ENVIRONMENTAL PROTECTION AGENCY

40 CFR Parts 63, 264 and 266

NESHAP: National Emission Standards for Hazardous Air Pollutants: Standards for Hazardous Waste Combustors (Reconsideration)

ACTION: Proposed rule.

Figure 1. Time Line for Phase 1 Replacement Standards and Phase 2 Standards – Existing Sources

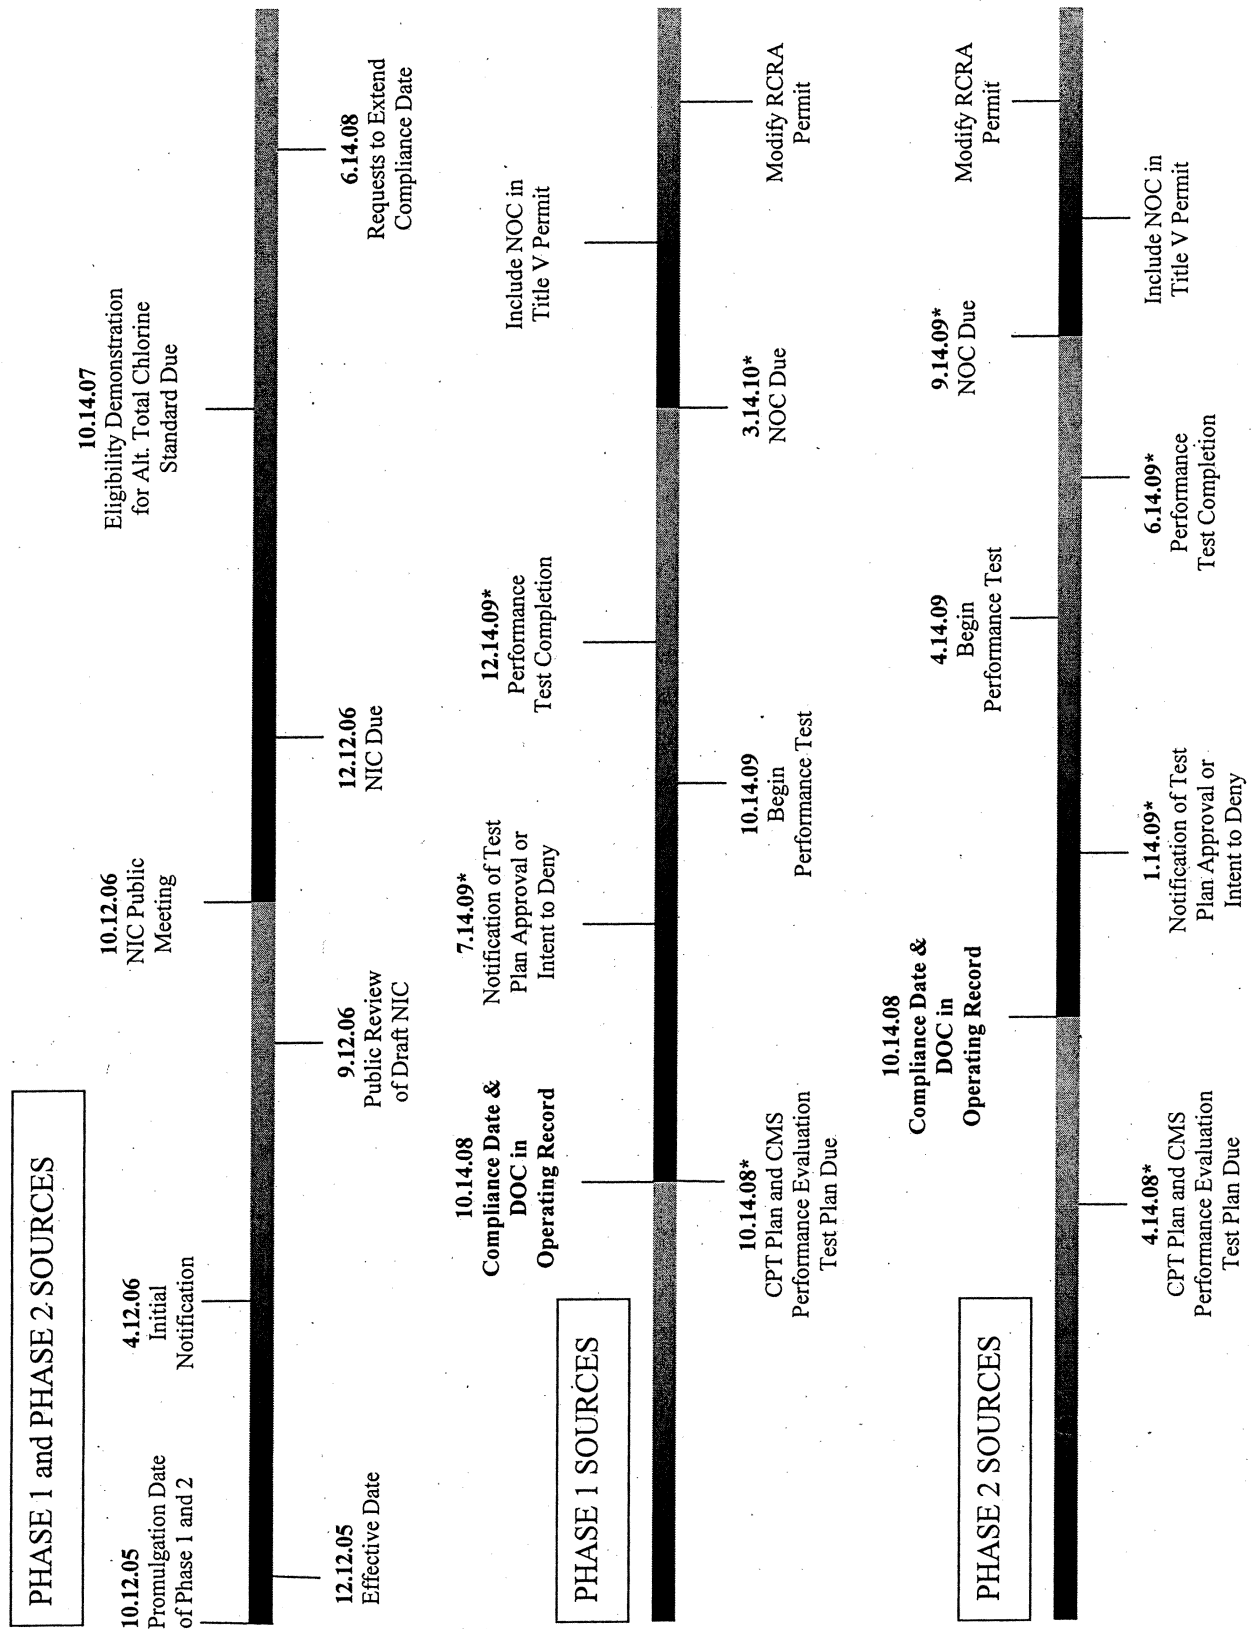
The time line labeled as Figure 1 published in the final rule at 70 FR at 59524, depicts an incorrect "effective" date for the Phase 1 Replacement Standards and Phase 2 Standards final rule. As a result, all subsequent dates on the time line are also incorrect. The time line labeled as Figure 2 published in the final rule at 70 FR at 59525 incorrectly includes the rule's effective date, as well as subsequent dates based on the effective date. Today's notice revises both time lines to reflect the correct dates or time frames associated with the compliance activities for both Phase 1 and Phase 2 sources. In addition to revising the dates, we felt it would be helpful to include the following remarks for both Figures 1 and 2.

With respect to figure 1, the time line is now broken into three sections to reflect the separate requirements (i.e., different time frames) negotiated for Phase 1 sources for the Replacement Standards. The first section of the time line, beginning with the promulgation date, provides compliance activities and dates applicable to both Phase 1 and Phase 2 sources. The second and third portions of the time line represent Phase 1 and Phase 2 sources individually, beginning with the first compliance activity that specifies a different deadline; that is, the comprehensive performance test (CPT) plan and continuous monitoring system (CMS) performance evaluation test plan due date.

Note that the dates on the time line generally do not apply to sources that elect to comply with the final standards early, as well as to sources that have received site-specific compliance date or performance test date extensions. Also, as a result of expanding the time line into three sections from the previous two, we have removed the note at the bottom of the page, identified by an asterisk that discussed Title V requirements, to provide better visual clarity. Rather, we have chosen to

Finally, the compliance activity dates that are tied to when sources commence their performance test are identified with an asterisk. We characterize these dates as "no later than dates." This assumes that the source commences testing on the last allowable day. All compliance activities marked with an asterisk would therefore shift back by the number of days the source commences testing prior to the last allowable day. For example, if a Phase 2 source commences testing on April 4, 2009 (versus the 14th, which is the last allowable day without an extension), then it must submit its CPT plan and CMS performance evaluation test plan on April 4, 2008. Also, that source must complete its CPT by June 4, 2009 and submit its notification of compliance no later than September 4, 2009.

Figure 2. NIC and CPT Plan Time Line - New Units

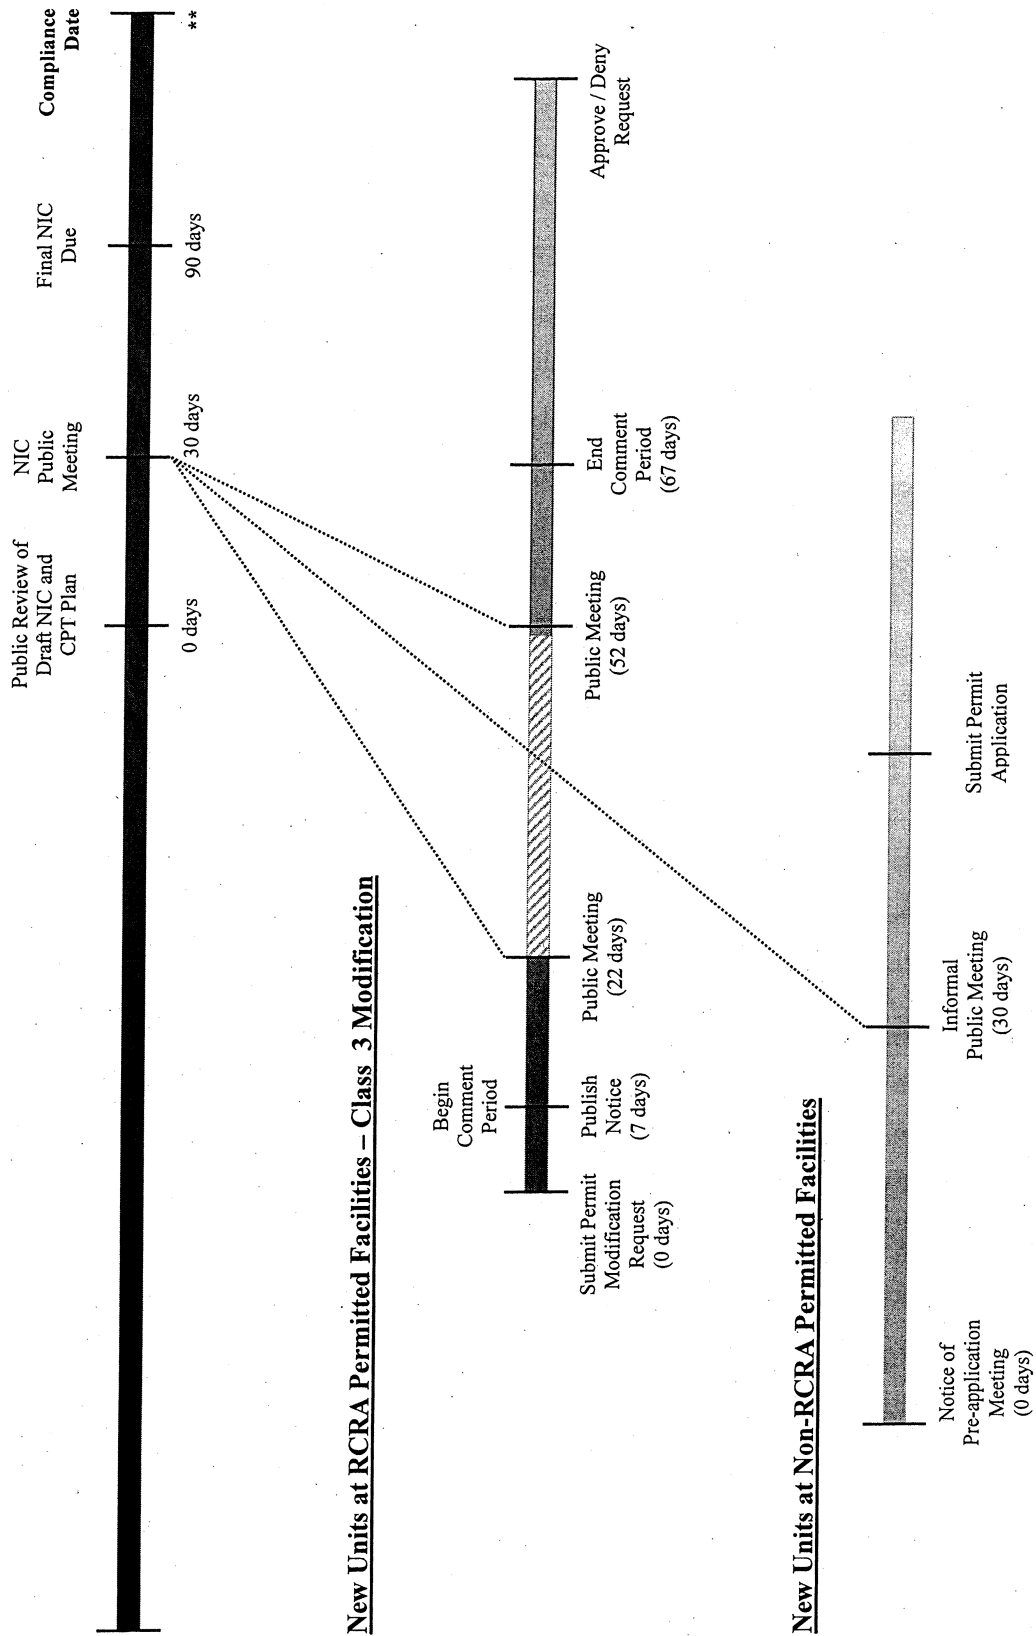
In regard to Figure 2, we have removed the dates from the time line, since they would not be representative of a new unit's compliance deadlines. A new unit's compliance activity deadlines are based on when it begins operations, which is the unit's compliance date and the date it must place a Documentation of Compliance in the operating record. Thus, the effective date of the rule is not applicable to new units and consequently, the Notice of Intent to Comply (NIC) provisions in §§ 63.1210(b)(3) and (c)(1) that specify a deadline based on the effective date of the rule, also would not apply. Since we have always intended that new units follow the same NIC procedures as existing units, we have revised §§ 63.1210(b)(3) and (c)(1) to also include the period of time between the NIC activities so that they correctly apply to both existing and new units. (See Section VII.C (Clarifications to the NIC Provisions for New Units) below for additional discussion.) The time line now reflects the period of time that elapses between public review of the draft NIC and CPT plan, the NIC public meeting, and the final NIC submission deadline. Aside from the corrections

While revising the time line for new units (see Figure 2 shown above in Section VI (Revised Time Lines)) it became apparent that we overlooked the fact that the final rule's effective date has no bearing on new units. A new unit's compliance activity deadlines are based on when it begins operations, which is the unit's compliance date and the date it must place a Documentation of Compliance in the operating record. Therefore, the NIC deadlines are only based upon each individual NIC compliance activity. For example, the clock will begin when the new unit provides the draft NIC and draft CPT plan to the public for review. Once the draft NIC and draft CPT plan are made available for public review, the combined public meeting must occur 30 days later, followed by the final NIC submission an additional 60 days later. Since the public meetings for the NIC and the RCRA pre-application or modification request must occur simultaneously, we anticipate that the new unit will plan accordingly and work with its permitting authorities to determine the most suitable time to begin the NIC compliance process.
